2.15 Structures and Servicing Systems

The information in this section of the reference ABWR DCD, including all subsections, tables, and figures, as modified by the STP Nuclear Operating Company Application to Amend the Design Certification rule for the U.S. Advanced Boiling Water Reactor (ABWR), "ABWR STP Aircraft Impact Assessment (AIA) Amendment Revision 3," dated September 23, 2010 is incorporated by reference with the following departures.

Table 2.15.5c Reactor Building Safety-Related Equipment HVAC System

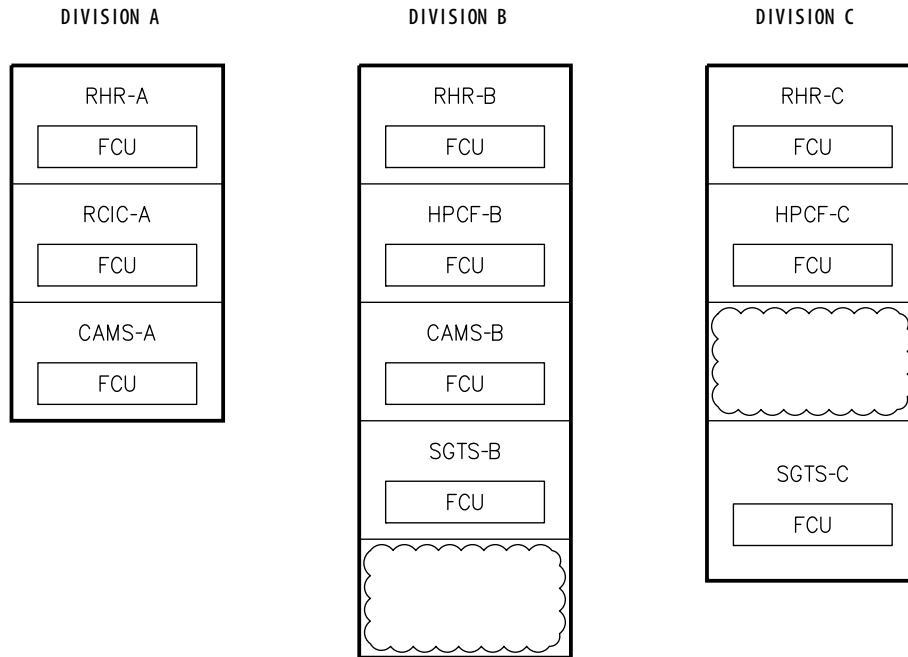
Inspections, Tests, Analyses and Acceptance Criteria		
Design Commitment	Inspections, Tests, Analyses	Acceptance Criteria
4. The FCS room FCUs are initiated upon a manual FCS start signal. <u>Not used.</u>	4. Tests will be conducted on each as built FCS room FCU using a simulated initiation signal. <u>Not used.</u>	4. The FCS room FCU starts upon receipt of a signal indicating FCS start. <u>Not used.</u>

Figure 2.15.5e Reactor Building Safety-Related Equipment HVAC System

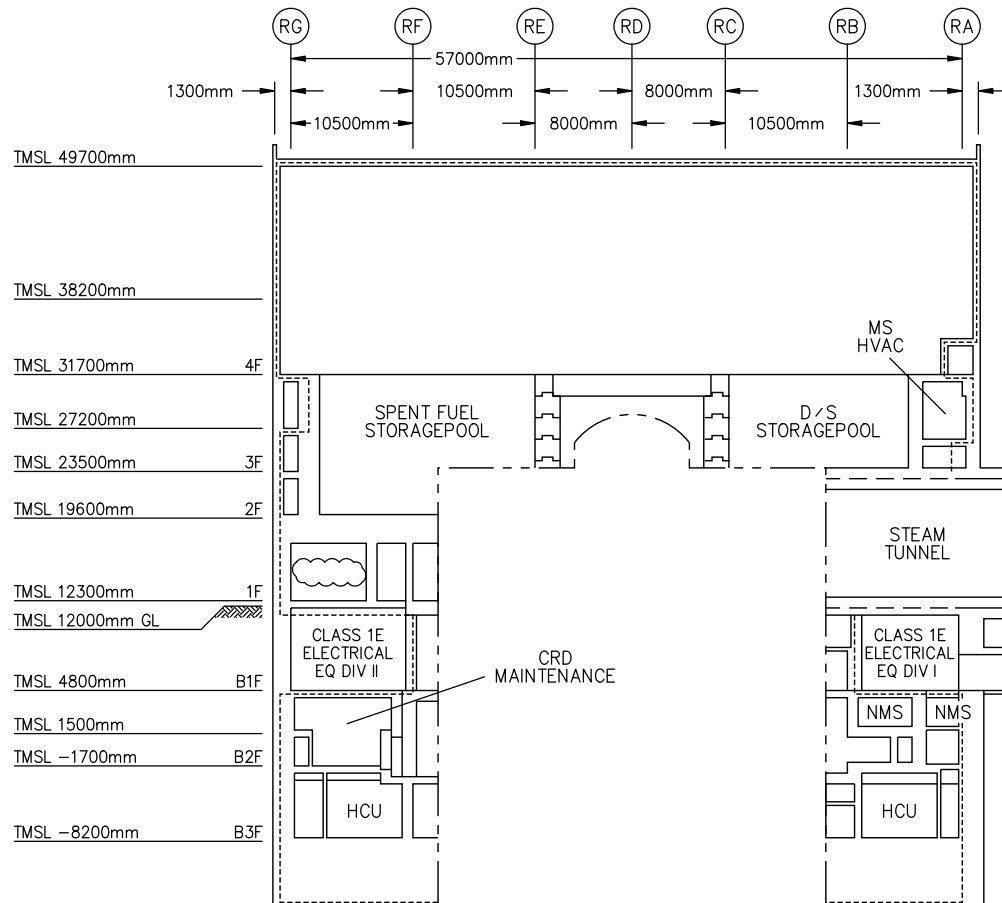
STD DEP T1 2.14-1 (Figure 2.15.10a, Figure 2.15.10j, Figure 2.15.5e, Table 2.15.5c)

The Residual Heat Removal (RHR) System, High Pressure Core Flooder (HPCF) System and Reactor Core Isolation Cooling (RCIC) System pump room FCUs are automatically initiated upon startup of their respective room process pump. The Containment Atmospheric Monitoring System (CAMS) and Standby Gas Treatment System (SGTS) room FCUs are automatically initiated upon isolation of the Reactor Building Secondary Containment HVAC System. ~~The Flammability Control System (FCS) room FCUs are also initiated upon a manual FCS start signal.~~

Figure 2.15.12a Control Building Arrangement, Section A-A

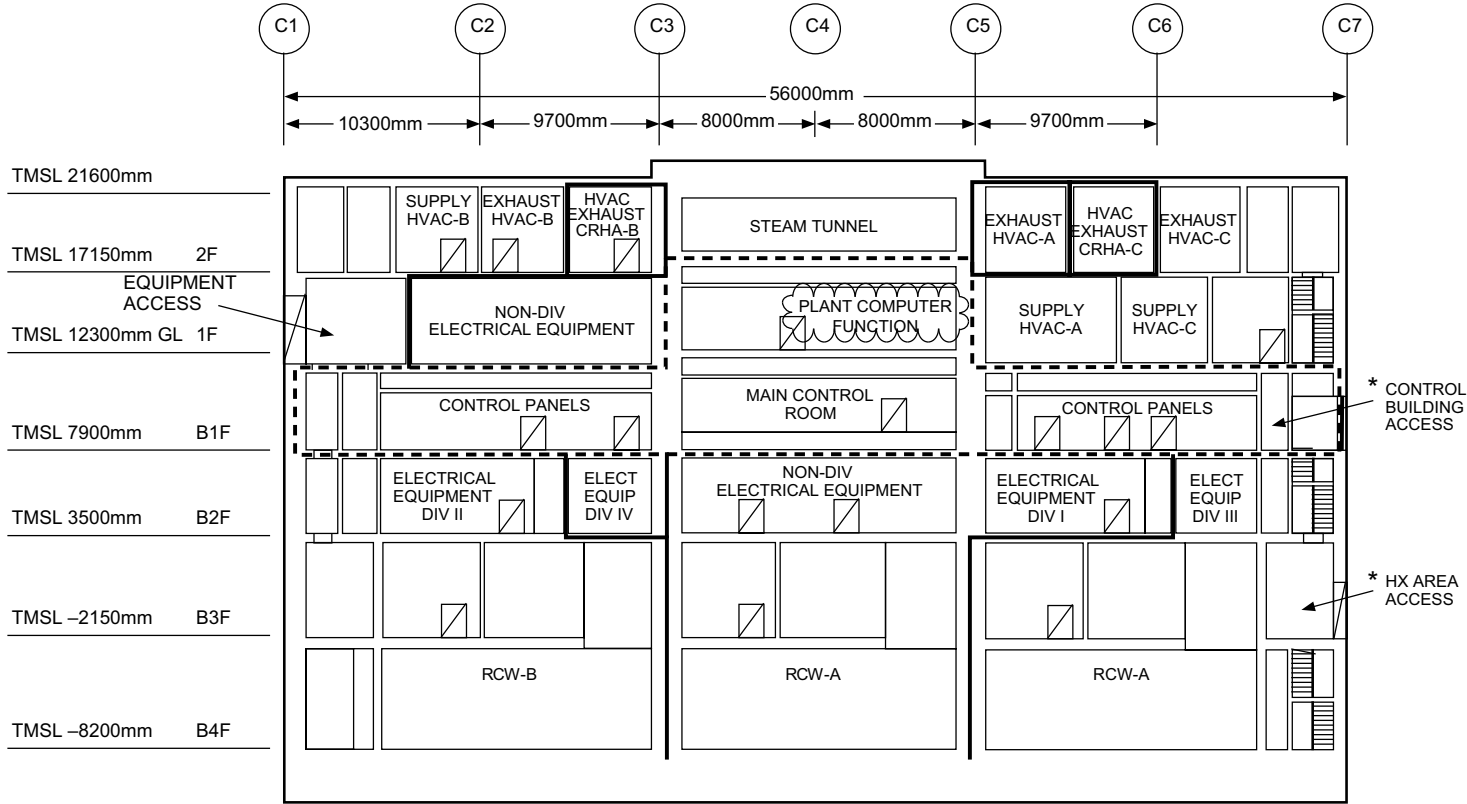
STD DEP T1 3.4-1 (Figure 2.15.12a, Figure 2.15.12b, Figure 2.15.12g)
